DR98-042  
PB98-015

**Esquire Plaza Hotel –  
26-Plus Story Hotel Tower New Construction, and  
Public Market Building Rehabilitation as Entrance,  
Lobby, Restaurants, Meeting Rooms and Ballroom.**

**Public Market Building: Essential Structure, listed in  
the City's Official Register of Historic Structures and  
Preservation Areas.**

REQUEST:

NORTH (J STREET) ELEVATION

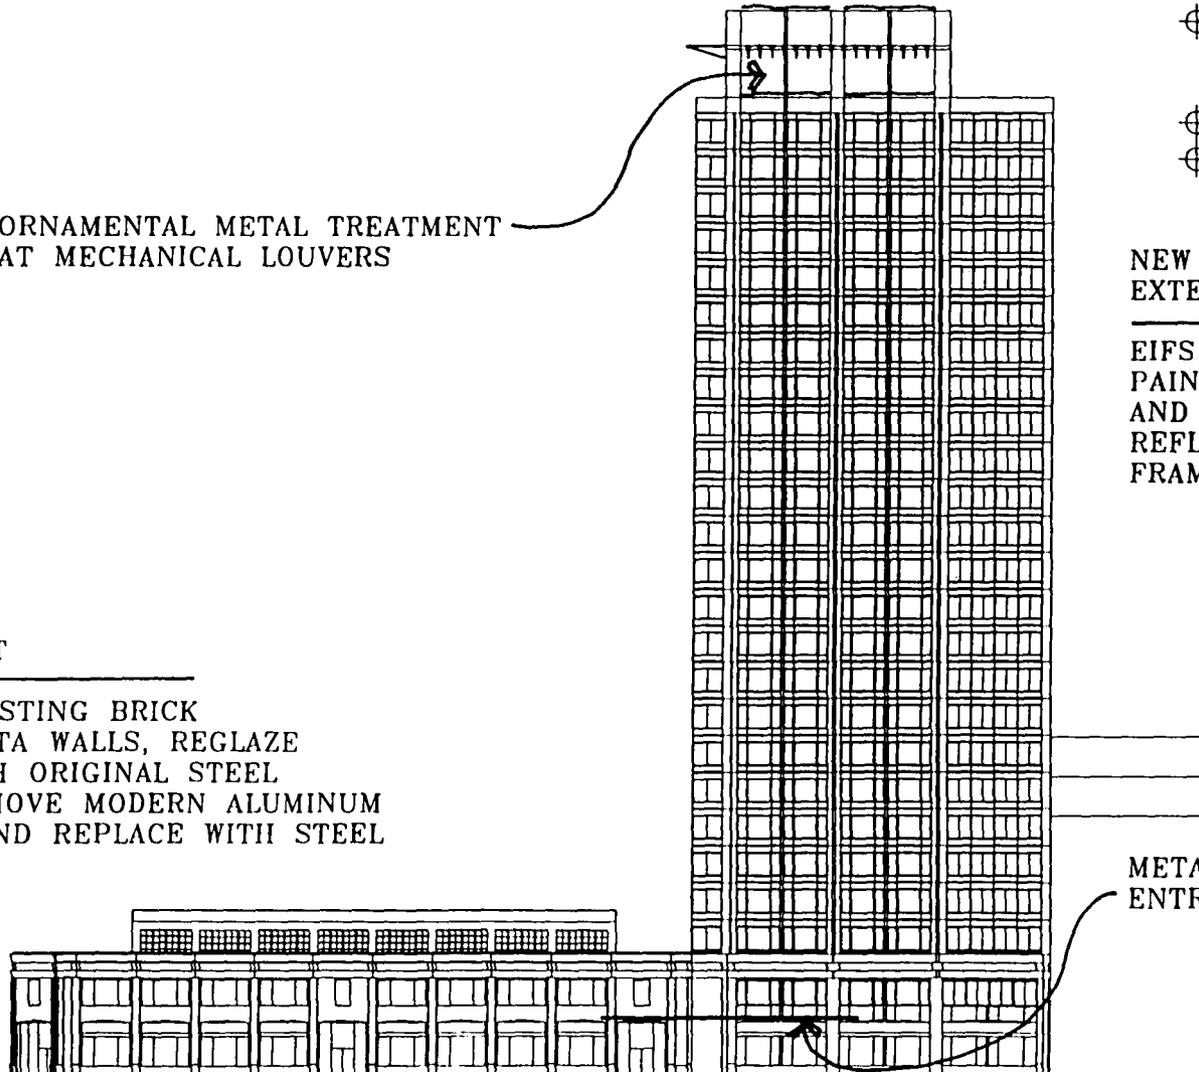
- d. **(Pedestrian Edges)** 1. Large areas of wall without glazing should be avoided.
2. **New Tower:** Since this tower could possibly be one of the highest in Sacramento, a more inspired design is strongly encouraged and would be warranted for such a key visual element in Sacramento's skyline. Consider, what would Julia Morgan have designed? What wonderful top would she have created? We suspect a rooftop garden with fanciful pergolas, perhaps? More inspired design options for the new tower structure – recognizing its relative height, its relation to the pedestrian street level, and its relationship to the historic Public Market Building, as well as other neighboring structures – need to be considered in greater detail. Various options involving fenestration, articulation of horizontal and vertical lines, better definition and celebration of the tower's top, massing, colors,

- d. Maximum tower diagonals are required; 220'-0" for the lower tower, and 200'-0" for the upper tower.
2. Section 5.2.8 addresses building tops, and specifies that projects above 150'-0" in height must either provide a flat top to accommodate an emergency helicopter, or a three dimensional top. Either design must provide a decorative and distinctive cap to the building. The proposed building elevations present a top that lacks these qualities, and a more distinctive top is essential for this structure.

SOUTH (ALLEY) ELEVATION

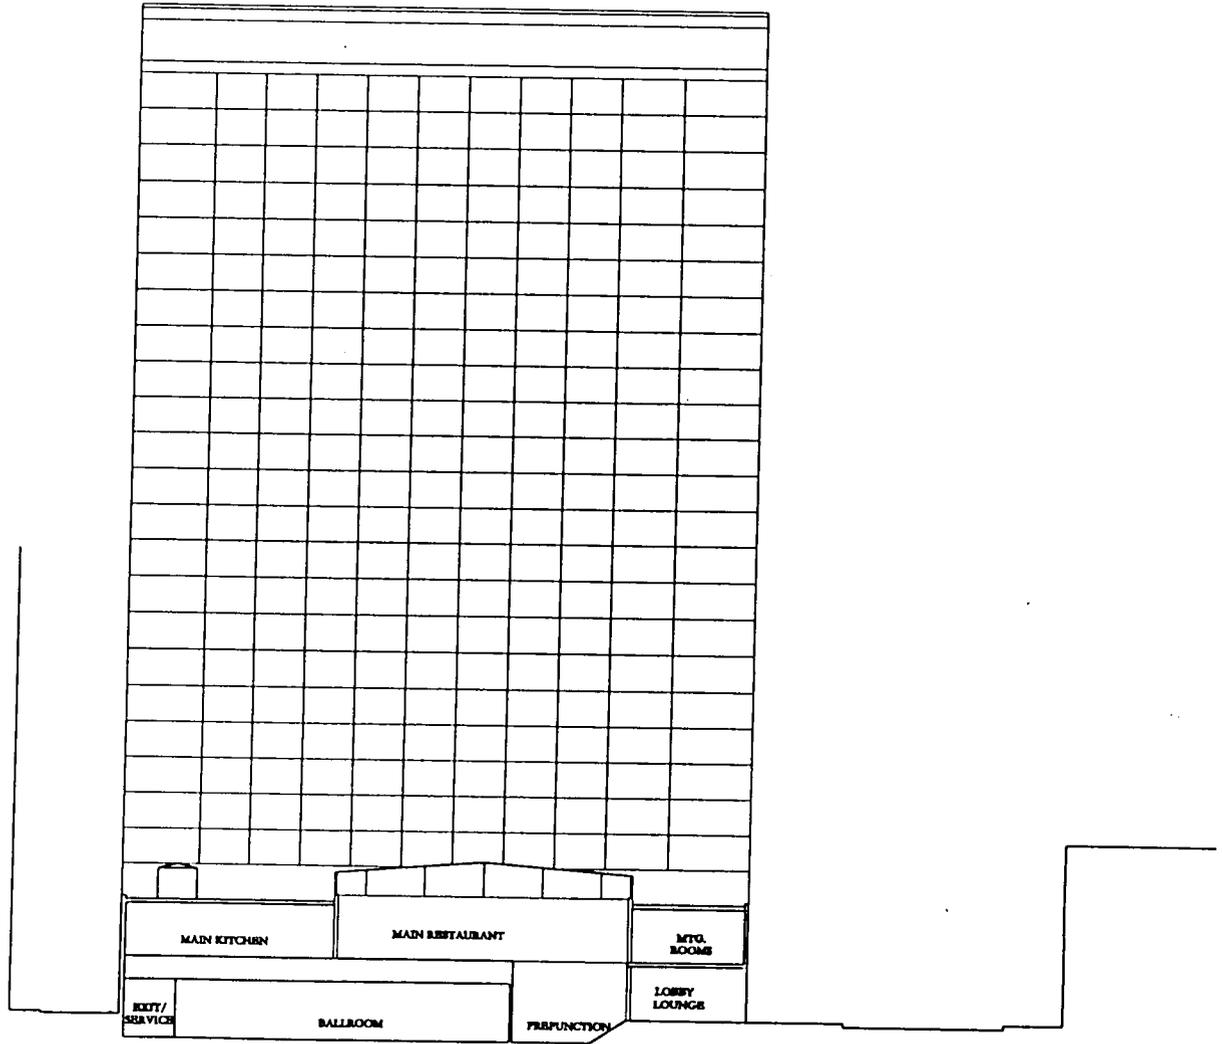
- b. Setbacks of 5'-0" and 10'-0" respectively are required at the lower and upper tower areas.
  - c. Rear walls also require 4'-0" setbacks off of a designated alley pedestrian way, and 5'-0" and 10'-0" respectively at the lower and upper towers.

DROP OFF SCHEMATIC AND SITE PLAN

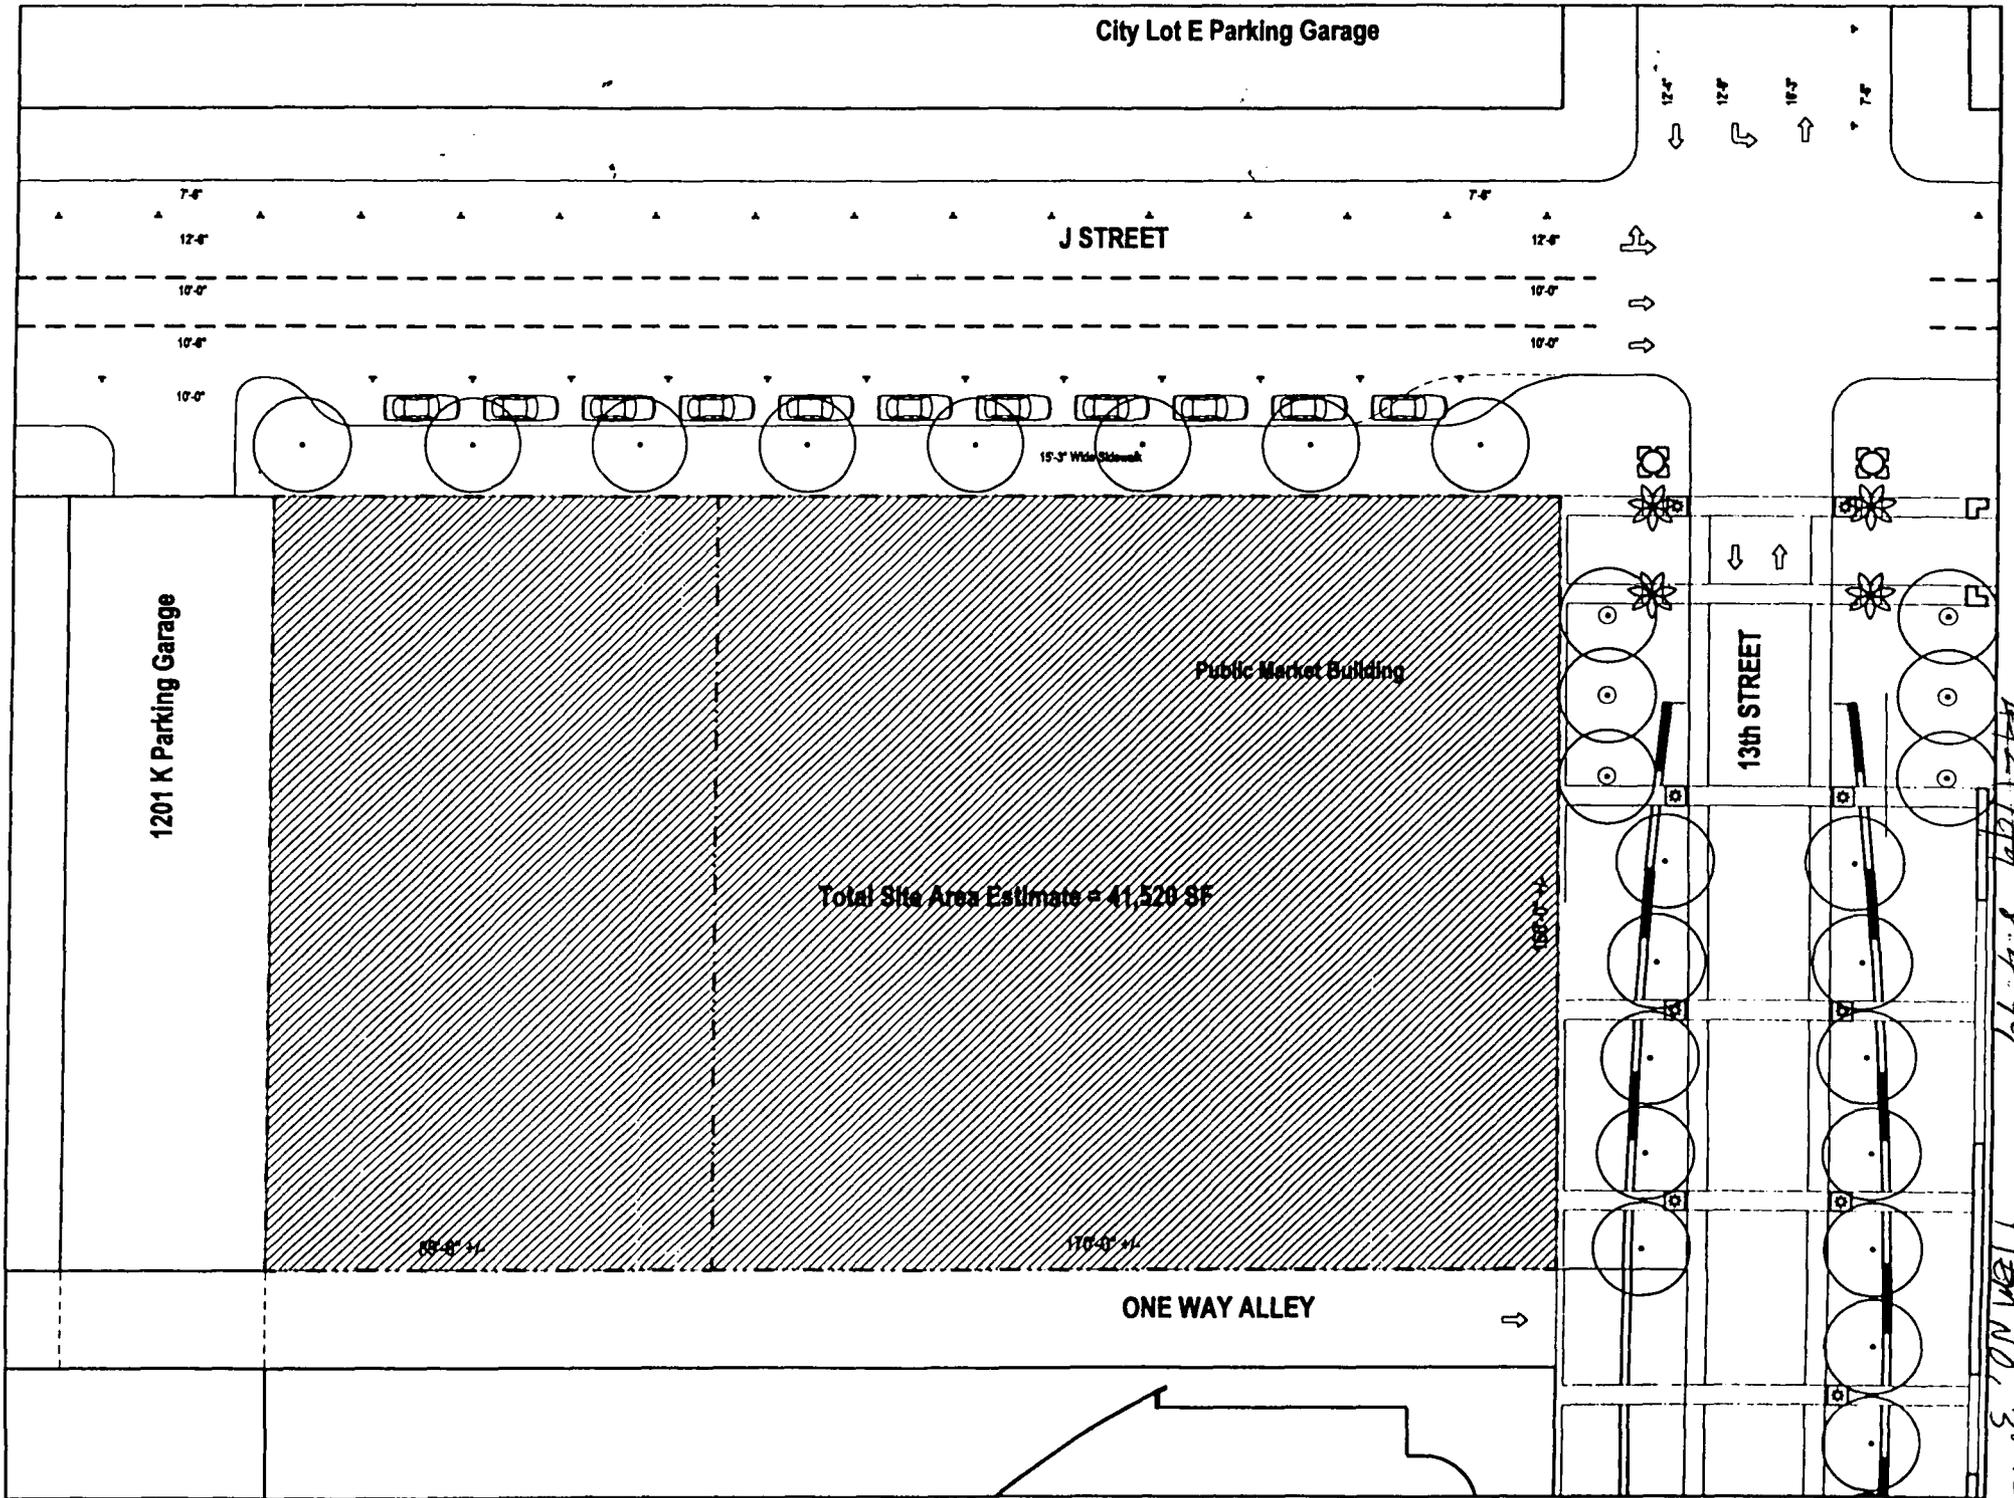
3. **Proposed Skybridge:** Staff appreciates that the skybridge will not be a part of this project.
4. **13<sup>th</sup> Street Sidewalk at Proposed Sidewalk Café:** Consideration of an adequate pedestrian area around the proposed sidewalk café is important. It may be that the proposal would provide enough sidewalk area for the pedestrian volumes to be expected on 13<sup>th</sup> Street with this project, the Esquire Plaza office tower and the IMAX Theater projects completed, but that information needs to be clearly articulated. Also requirements for serving alcoholic beverages at sidewalk cafes should be considered.
